ADDENDUM #5

Reference: Noorda Black Box Theater Addition and Remodel
Utah Valley University – Orem, Utah
DFCM Project No. 08017790

ADDENDUM - 5

Project: UVU Noorda Theater
DFCM Project Number: 08017790
Axis Project Number: 0804
To: Mike Ambre
From: Axis Architects
Date: August 16, 2008

PARTIAL PLAN SHEET S101

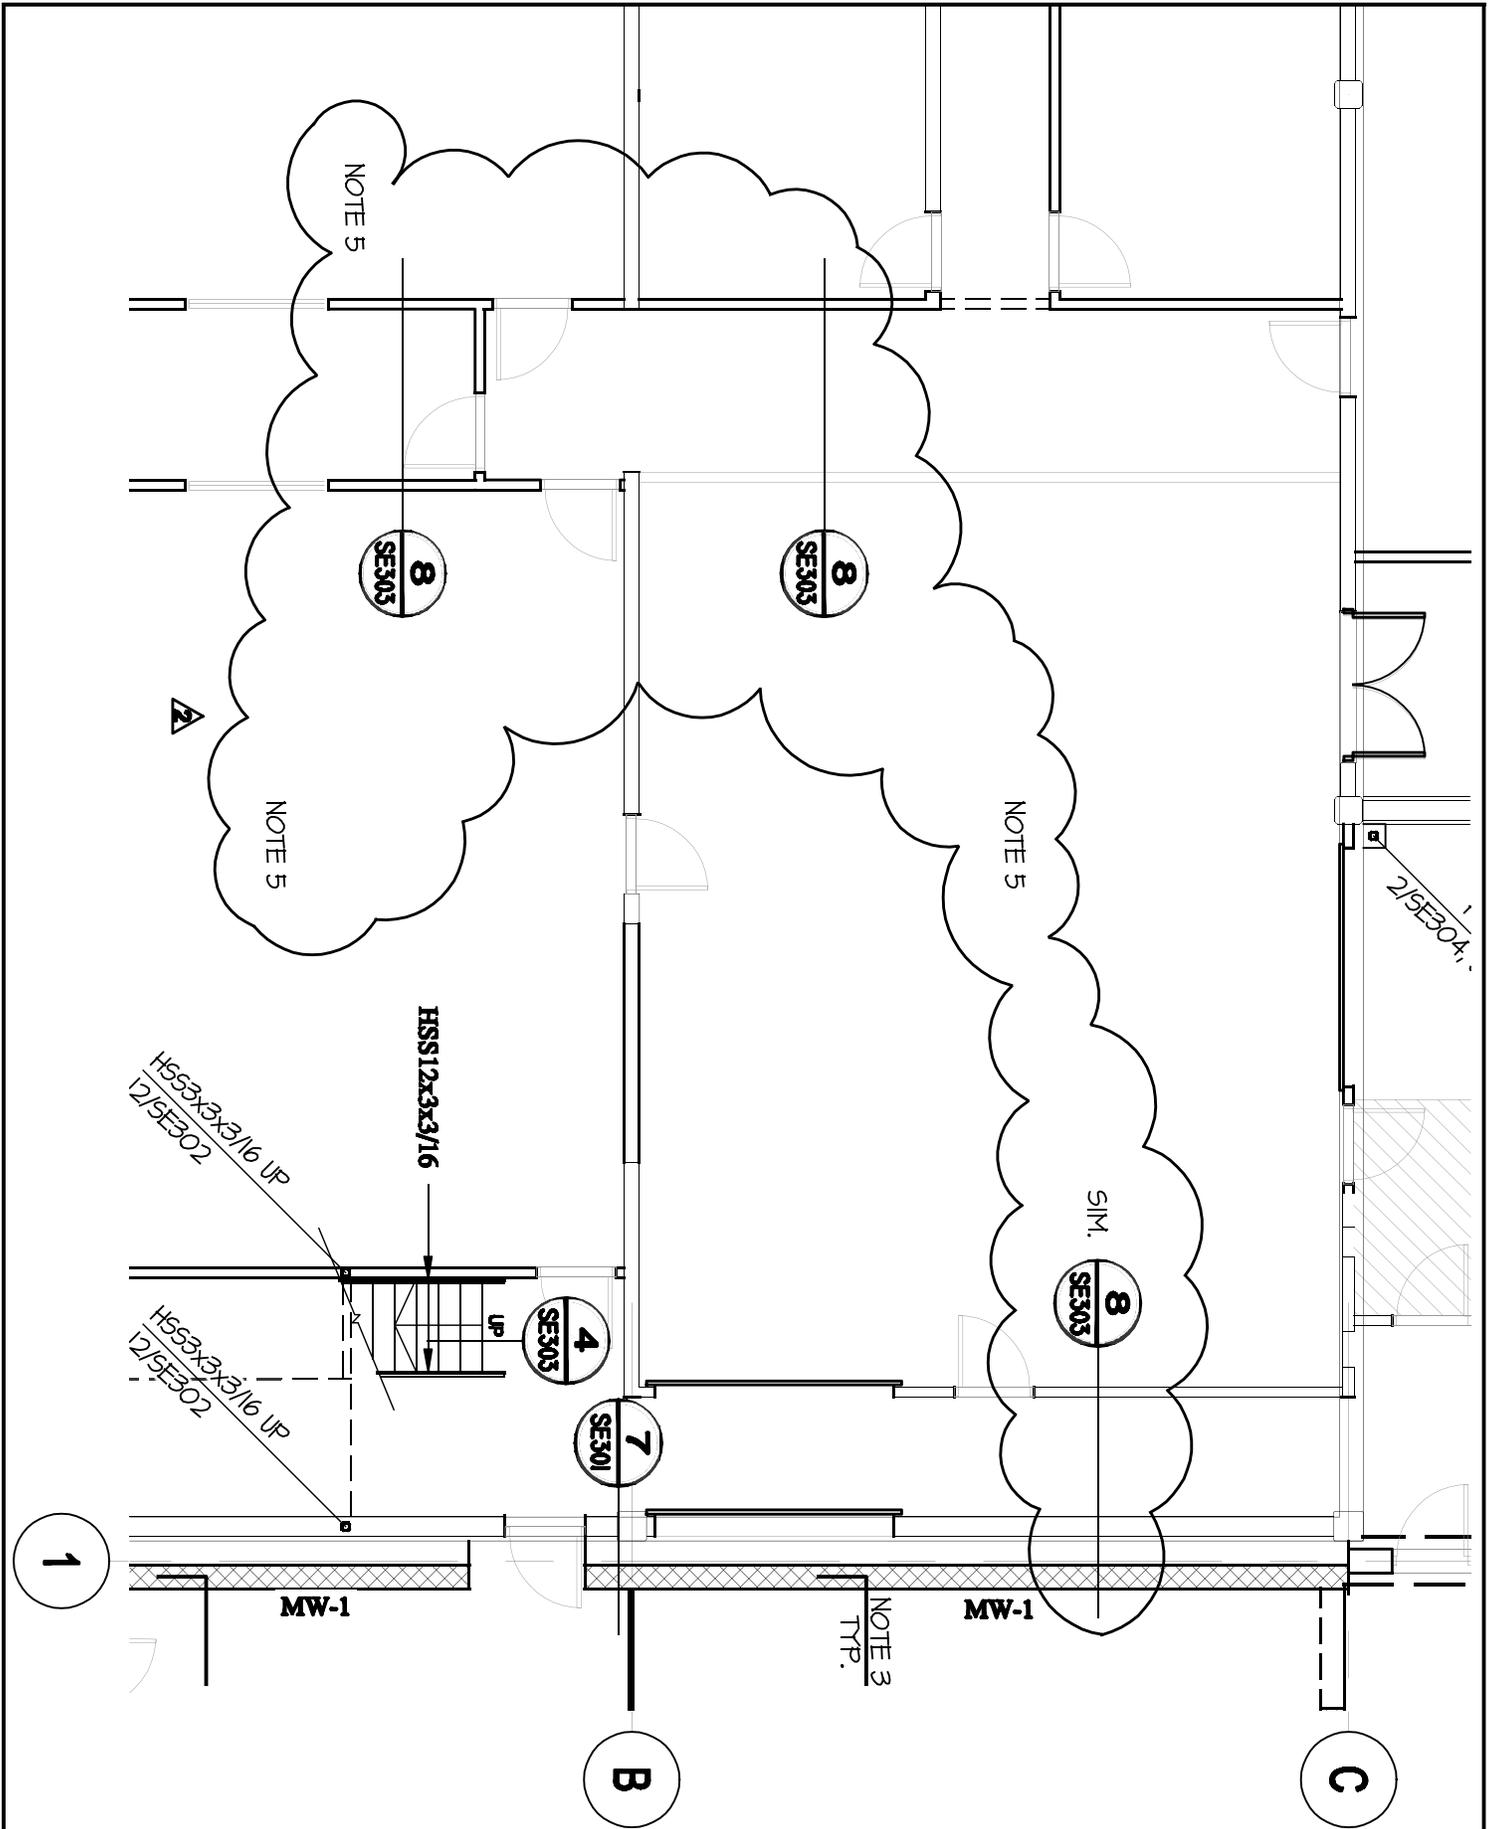
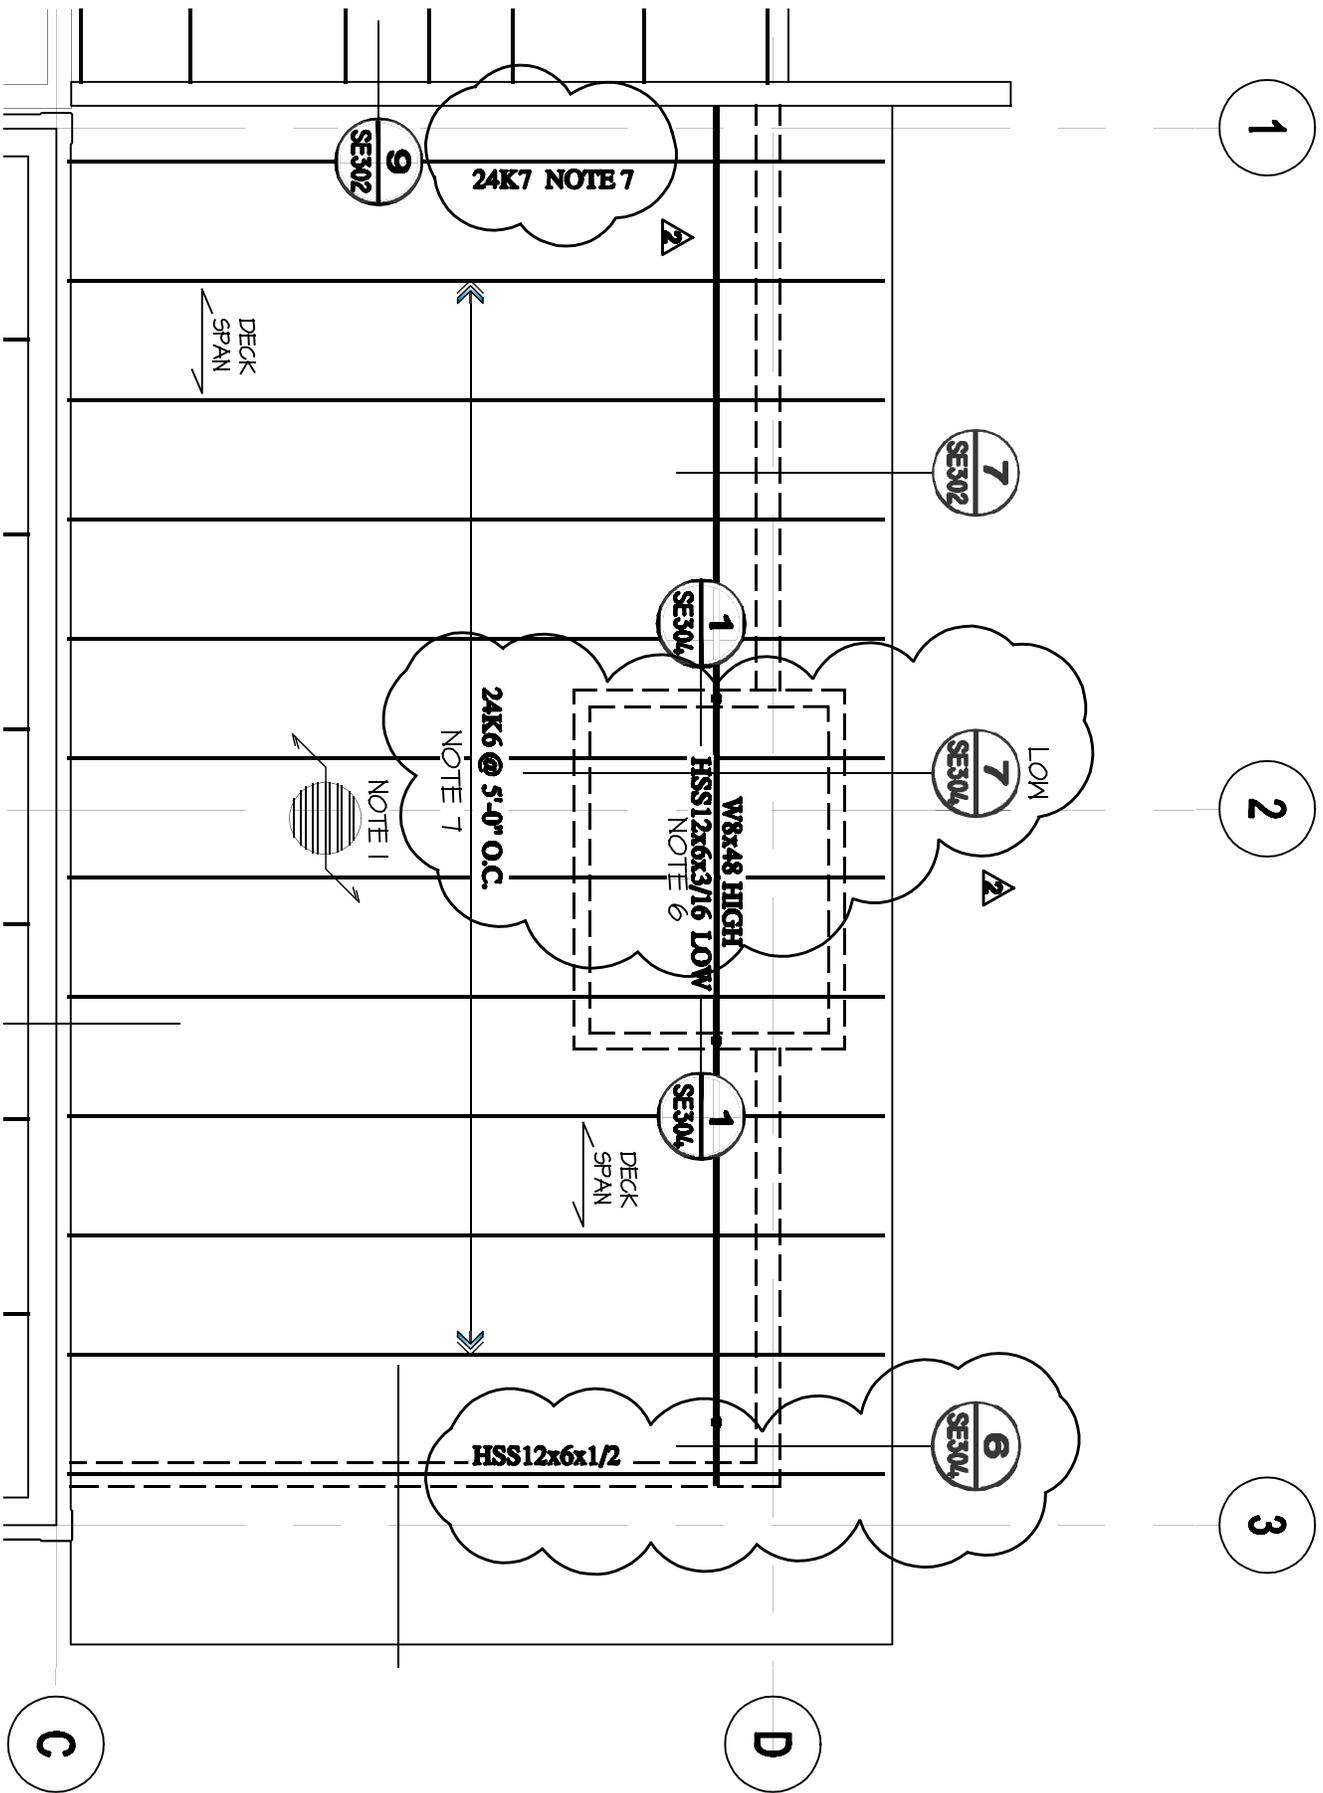
1. See attached partial plan.

PARTIAL PLAN SHEET S103

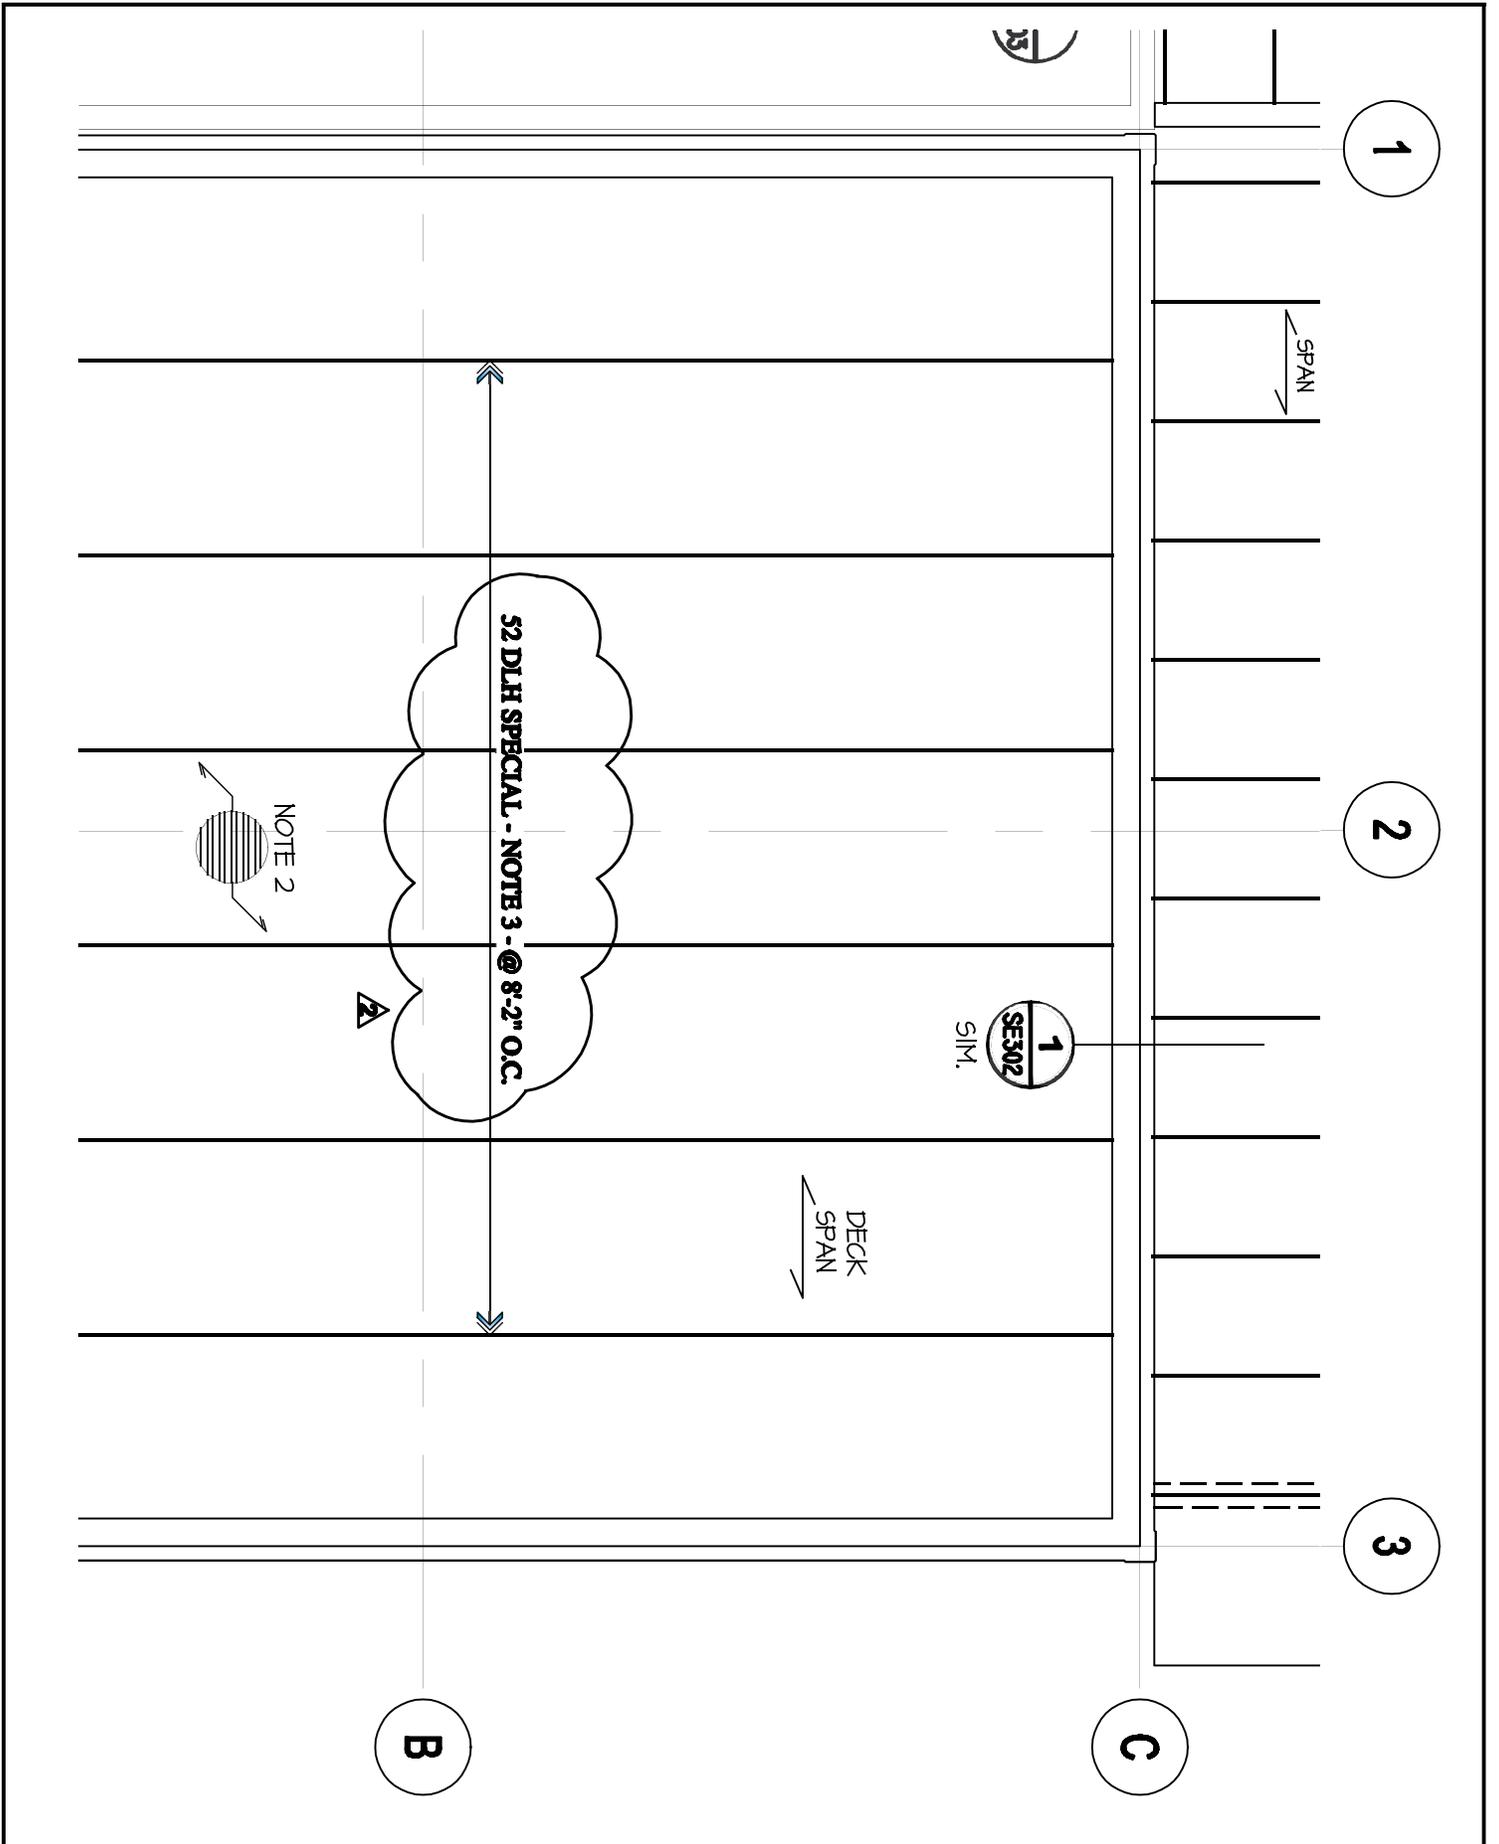
1. See attached partial plan.

2
 SCALE: 3/4" = 1'-0" SE301

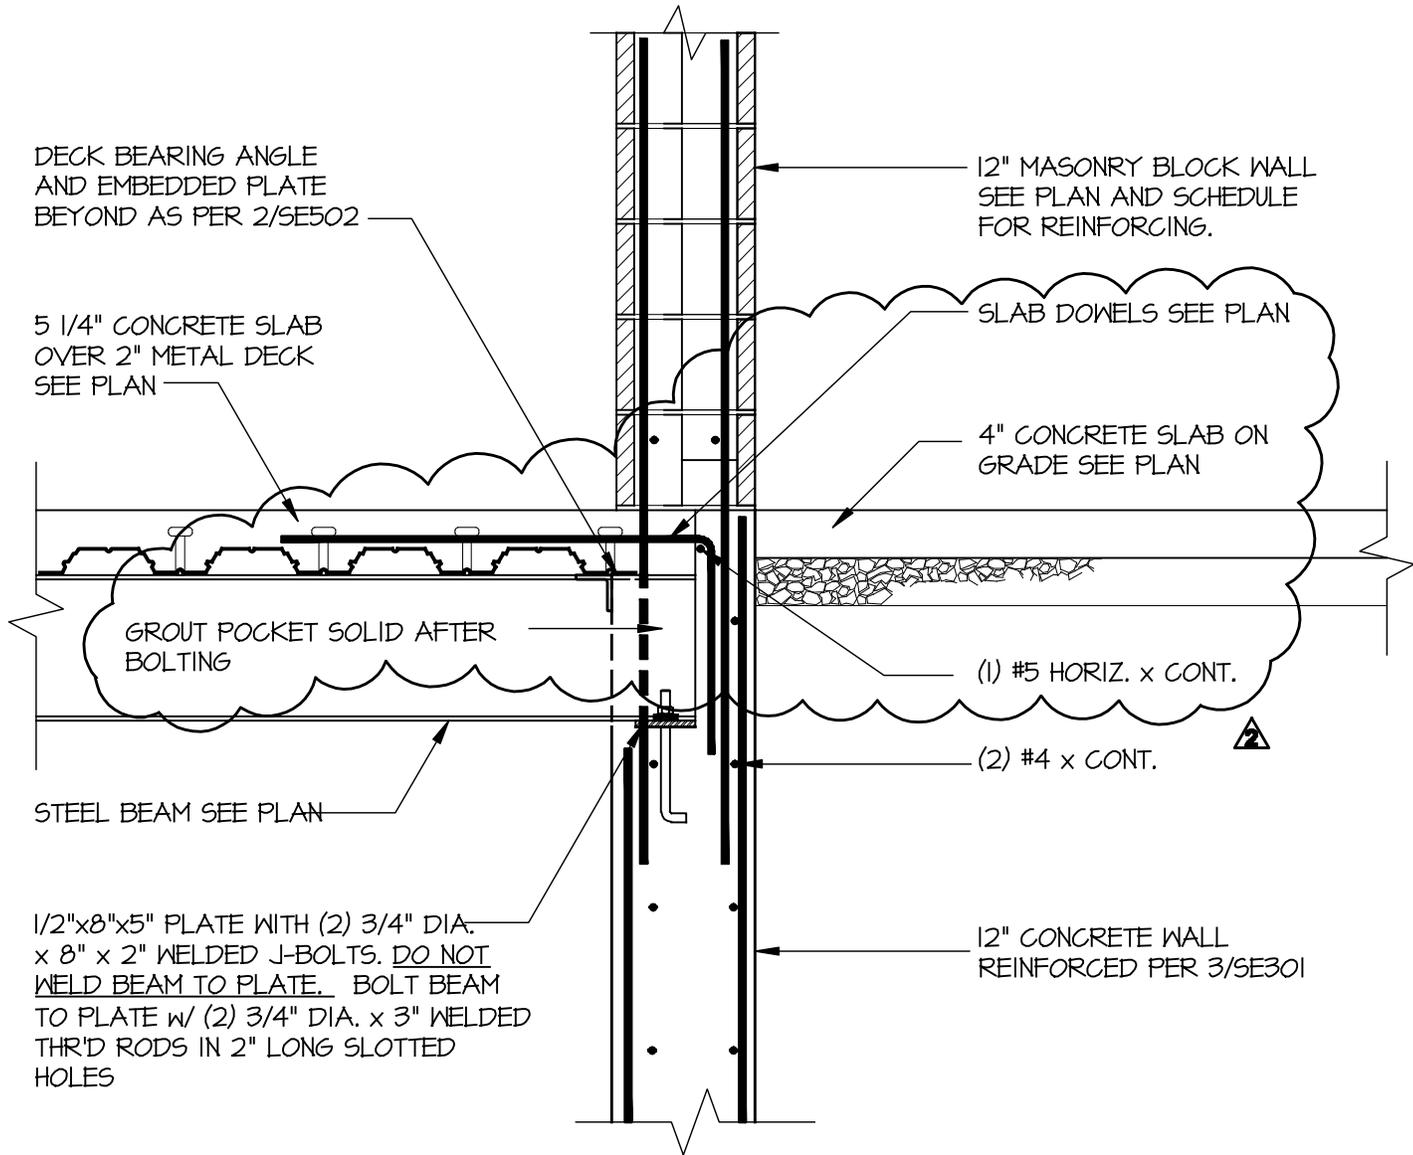
1. In detail 2/SE301, the concrete foundation wall shall be 18" thick reinforced as per the general notes.
2. See revised detail 9/SE301.

3
 SCALE: 3/4" = 1'-0" SE302

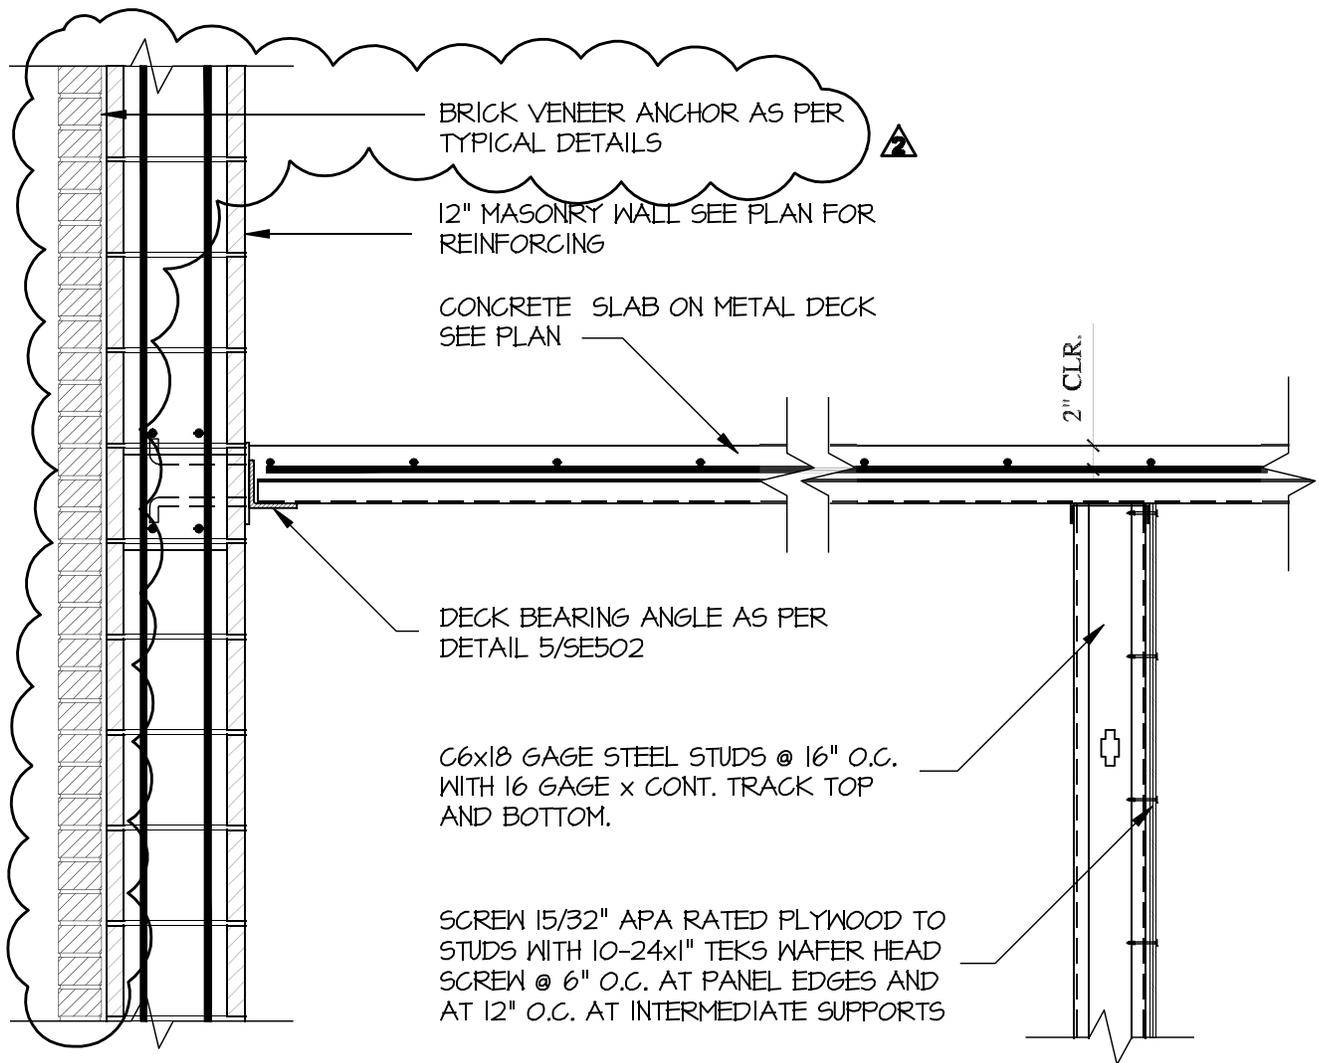
1. The masonry wall in detail 1, 2, and 3/SE302 shall be 12" thick with brick veneer anchored as per the typical details.
2. See revised detail 8/SE302.
